Agenda Item # 3

SUB-002658-2023 (HOLDOVER) & MOD-002791-2023

The Resubdivision of Southern Oaks Subdivision

- Subdivision approval to create three (3) legal lots of record from two (2) legal lots of record.
- Modification of a previously approved Planning Approval.

SITE PLAN

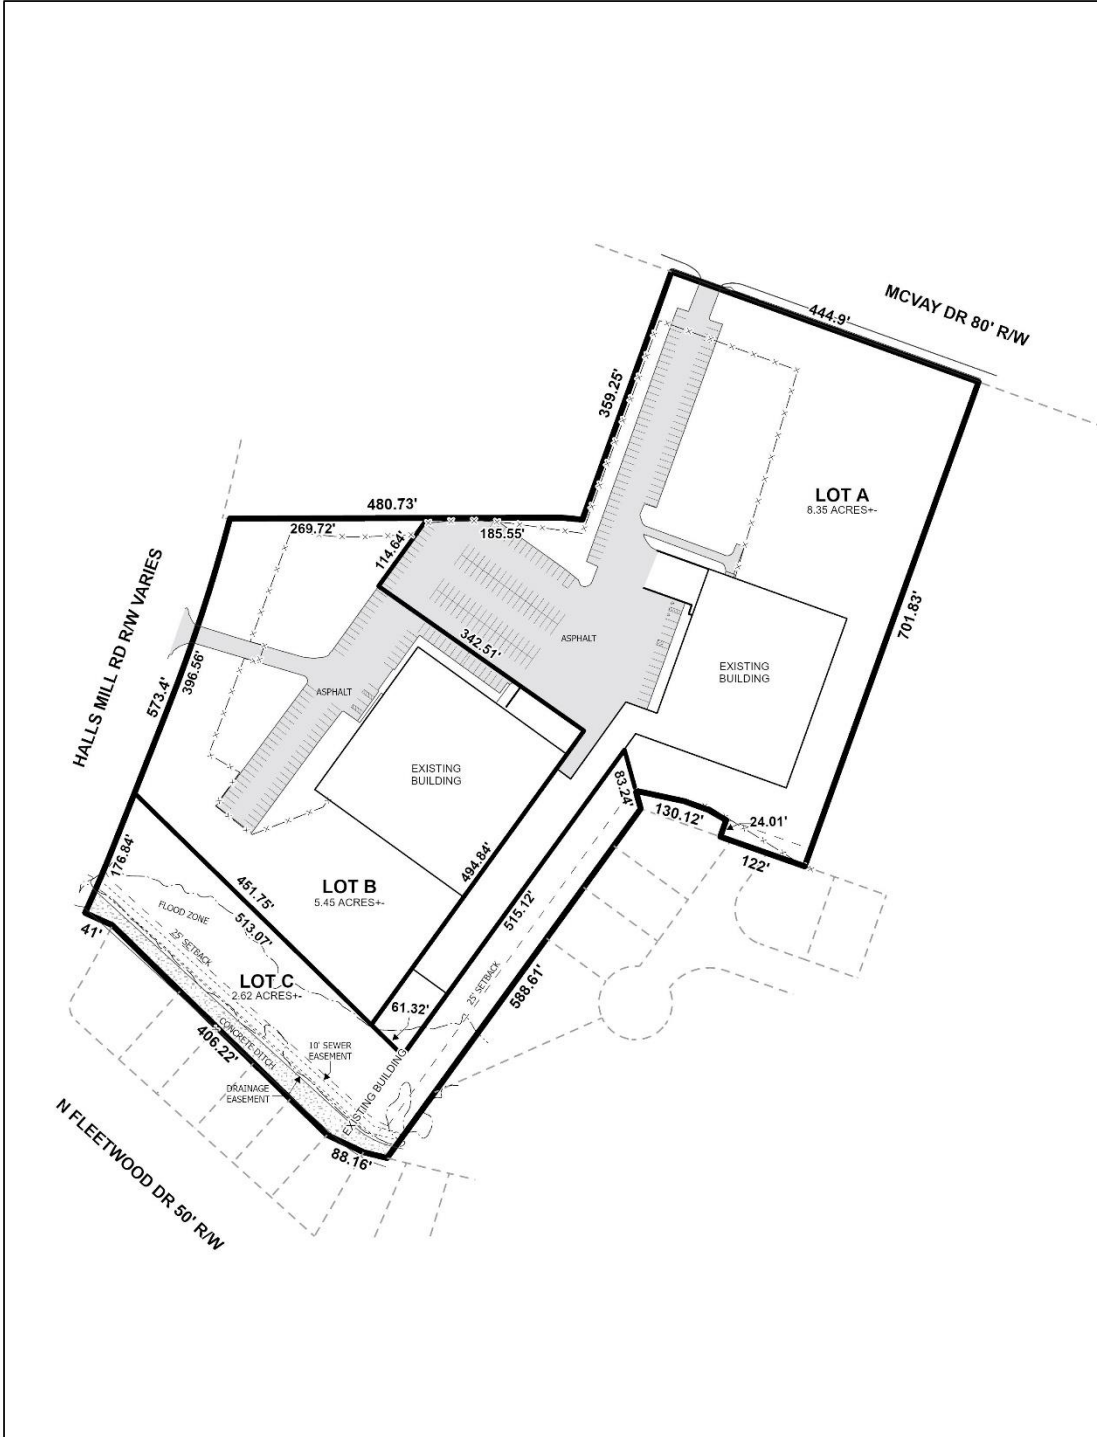
The site plan provided reflects the changes proposed by the associated Subdivision request, and includes the size of each proposed lot in square feet and acres. Two (2) of the proposed lots, Lots A and B, are developed and, as mentioned, are proposed to share a common lot line through an existing building, and through part of an existing parking lot. The resulting setbacks of the building on each lot should not be an issue, but shared access to the parking lot should be facilitated via the appropriate legal instrument (e.g. ingress/egress easement, reciprocal easement, etc.) and illustrated on the plat and Planning Approval site plan. This was requested by Staff as part of their review of the Subdivision request, but no additional information regarding the easement was provided, and no easement is depicted on the site plan. As such, revision of the site plan illustrating an easement granting shared access should be illustrated on the recorded site plan.

It should be noted that, while parking is illustrated, no information is provided for staff to verify the site has an adequate number of parking spaces. As such, if approved, revision of the site plan to provide a table noting the off-street parking requirements of Table 64-3-12.1 of Article 3 of the UDC for each use of the site must be required, along with the number of parking spaces provided.

Proposed Lot C is undeveloped and when it was rezoned to B-2 it was to serve as a buffer between the existing development and the adjoining residential neighborhood. A wooden privacy fence is illustrated along a portion of the site that abuts single-family residential property, but it does not extend the entire length of the property line where the site abuts other single-family residential properties. Recent aerial photos depict a wooded area that may serve as an adequate vegetative buffer, but it should be noted that where any portion of the subject site abuts a residentially zoned property, a buffer in compliance with the applicable standards of Article 3, Section 64-3-8 of the UDC is required to be provided and/or maintained. A note stating as much should be placed on the recorded site plan, if approved.

If approved, the site plan should be revised to illustrate the required 25-foot minimum building setback along each street frontage, per Sections 64-2-13.E. and 64-2-14.E. of the UDC for lots in B-2 and B-3 zoning districts within the Suburban sub-district.

McVay Drive North is inaccurately labeled “McVay Drive”. If approved, the site plan should be revised to correctly label McVay Drive North.

It should be noted that both the 2003 and 2022 Planning Approvals referenced continuation of the preservation status of two (2) Live Oak trees on the site, one with a Diameter at Breast Height (DBH) of 68-inches, and the other with a DBH of 74-inches. No trees are depicted on the site plan, but it appears the trees are still on the site. If approved, the site plan should be revised to illustrate each of these trees, depicting their sizes and noting their preservation status.

Finally, no dumpster pad is illustrated on the site plan, and no note regarding waste removal is provided. Any dumpster placed on the site must meet the placement and enclosure standards of Article 3, Section 64-3-13.A. of the UDC and illustrated on a revised site plan, if approved; or, placement of a note on the revised site plan stating curbside waste removal services will be utilized should be required.

2. Revision of the site plan to illustrate a cross-access easement between Lots A and B, or provision of a recorded legal document with the same information;

3. Revision of the site plan to provide a table noting the off-street parking requirements of Table 64-3-12.1 of Article 3 of the UDC for each use of the site, along with the number of parking spaces provided;

4. Provision of a note on the recorded site plan stating that a buffer in compliance with the applicable standards of Article 3, Section 64-3-8 of the UDC is required to be provided and/or maintained where any portion of the subject site abuts a residentially zoned property;

5. Revision of the site plan to illustrate the 25-foot minimum building setback line along each street frontage, per Section 64-2-13.E. and 64-2-14.E. of the UDC for lots in B-2 and B-3 zoning districts;

6. Revision of the site plan to correctly label "McVay Drive North";
7. Revision of the site plan to illustrate the two (2) protected Live Oak trees, depicting their sizes (68" and 74" DBH or larger due to growth) and noting their preservation status;

8. Revision of the site plan to illustrate any existing or proposed dumpster pads, or placement of a note on the recorded site plan stating curbside waste services will be utilized;
